Entrust Fashions Ltd. (Extended Building)

1. Shed-3 (G+1)

Observations

Bore hole layout in soil test report

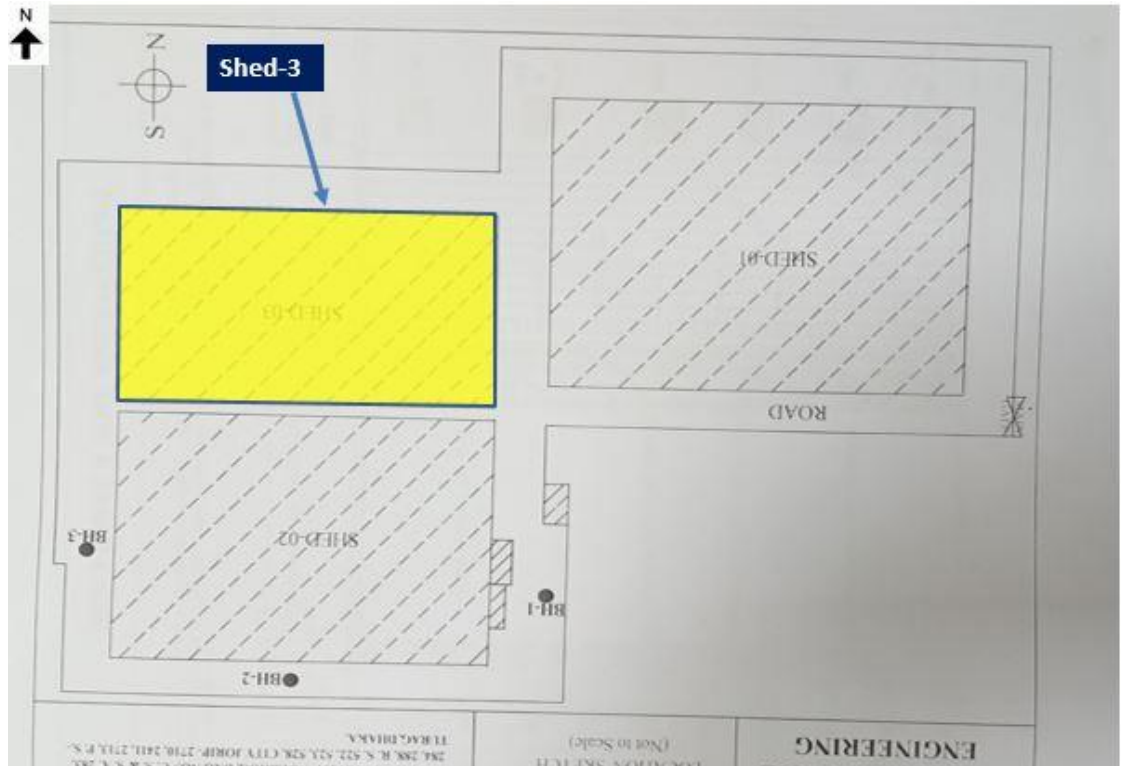
In addition, all the bore hole locations in the soil test report were found far away from the shed-3. The bearing capacity of soil under shed-3 needs to be checked by conducting more test as per BNBC.

Connections of bracings observed on site

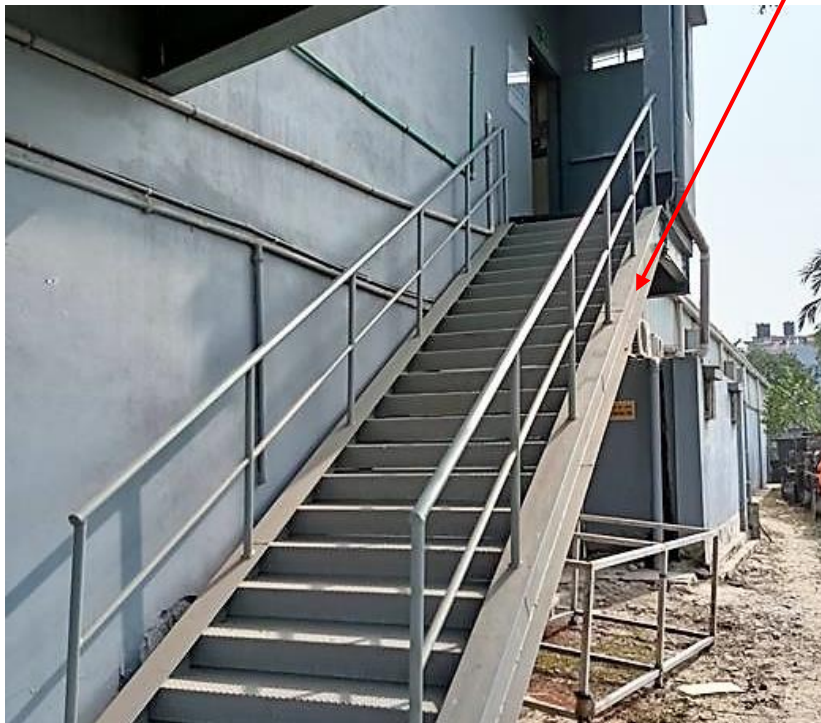
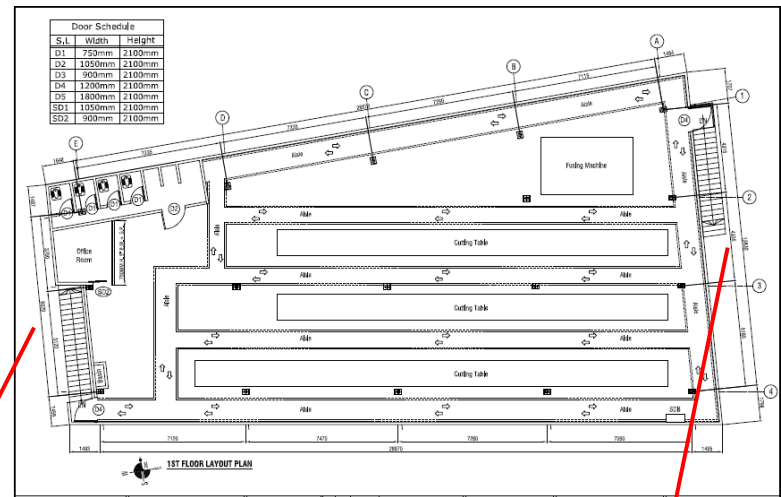
No connection details of the vertical bracings was provided in the as-built structural drawing of Shed-3.

Connection details was not provided for the cantilever areas.

There are two steel stairs on east and west side of the shed. No details of the stairs was provided in the as-built structural drawing.

Joint plate thickness was found
13mm at several locations

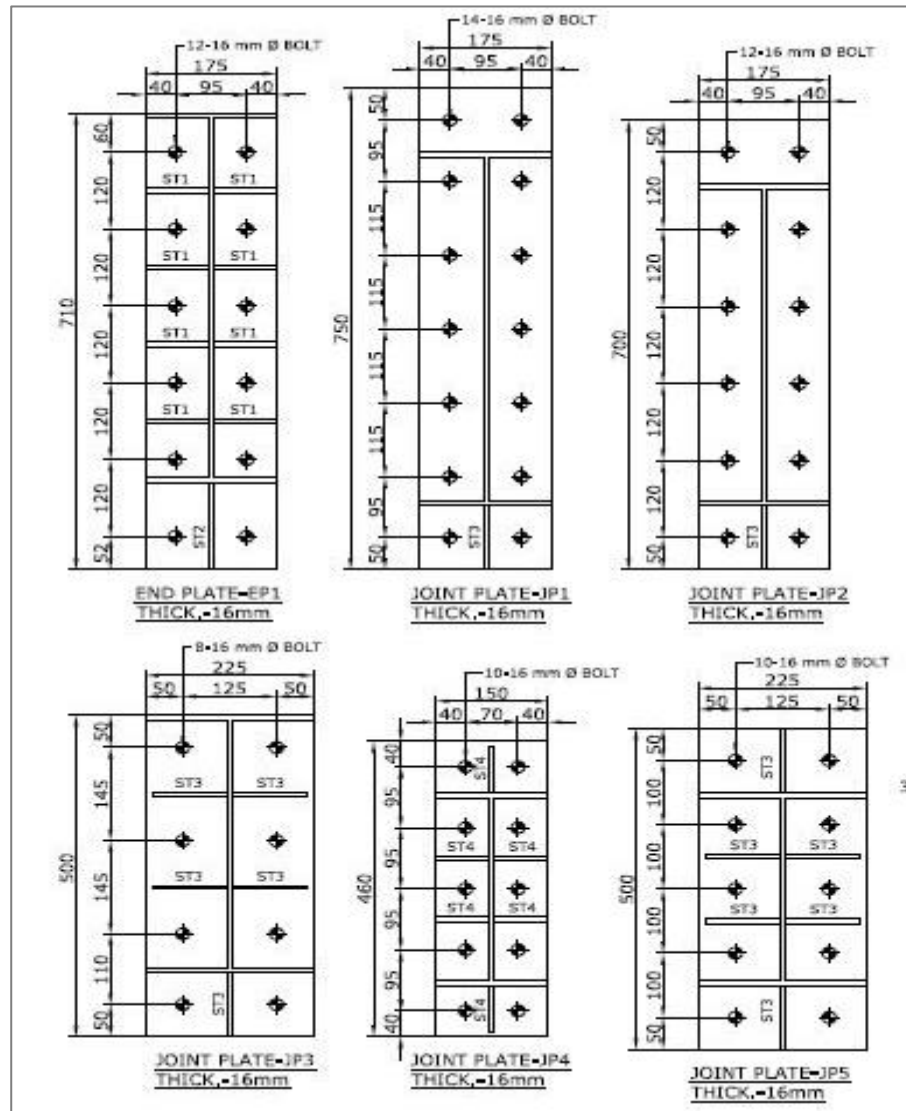
In connection details drawing all the joint plate thickness were mentioned as 16 mm.
